Remaining Comments for the Public Hearings regarding the DeBeers Canada Gaucho Kue Diamond Mine Proposal

October 22, 2012

On Behalf of The Deninu K'ue First Nation

Graph showing fork lengths versus net mesh size for fish caught in freshwater lakes in British Columbia (Hamley 1972, Plate 2007).

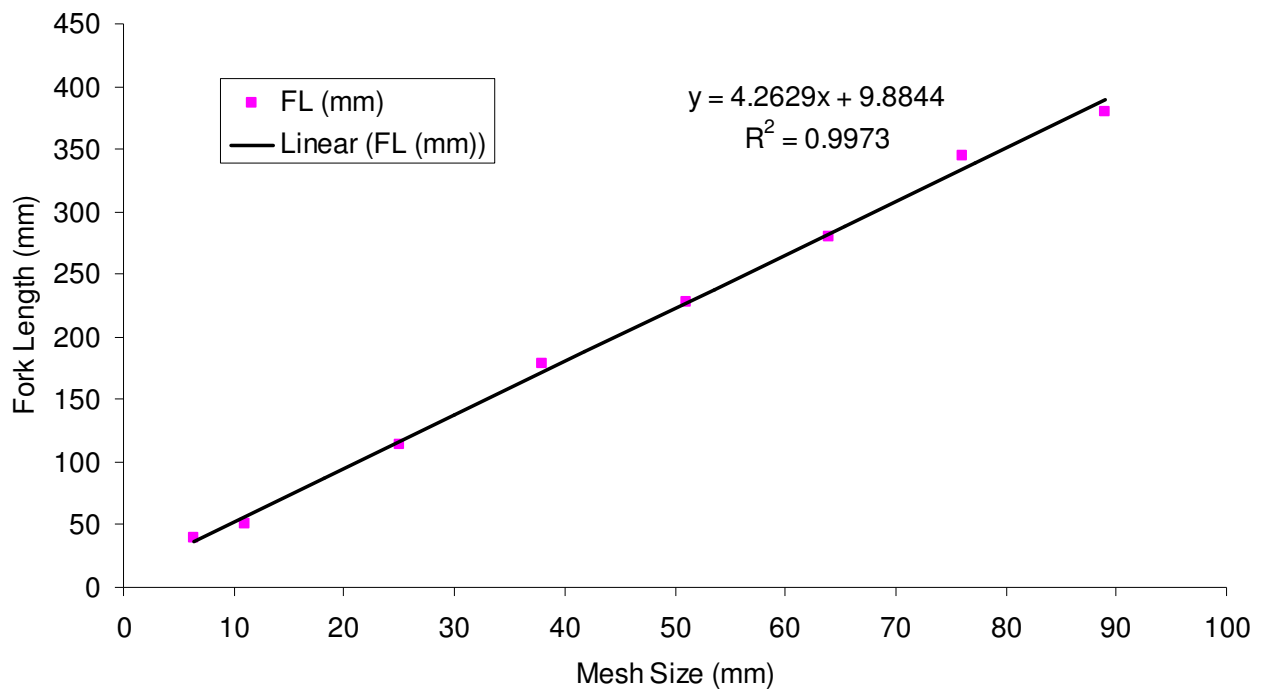
In response to our comments and the request for baseline work DeBeers Canada listed gillnetting, shoreline electrofishing, angling and minnow trapping as the fisheries methods that were used to support the population estimate based on the hydroacoustic day-time surveys. All four methods listed are commonly used as tools to assess species composition and species presence but cannot be used as population estimate tools on their own. DeBeers Canada further mentions that several mark-recapture programs were carried out to provide population estimates but DeBeers does not mention the results of the mark-recapture estimate. Based on another review of Section J 4.4.5 of Annex J the mark-recapture program did use nets with a minimum mesh size of 38mm which would result in mainly catching fish that are larger than approximately 180mm (see figure below). This results again in the complete exclusion of fish that are smaller than 180mm into this population estimate. DeBeers Canada therefore did not only exclude fish <180 mm from the analysis of the hydroacoustic surveys but also from the population estimate based on the mark-recapture program.
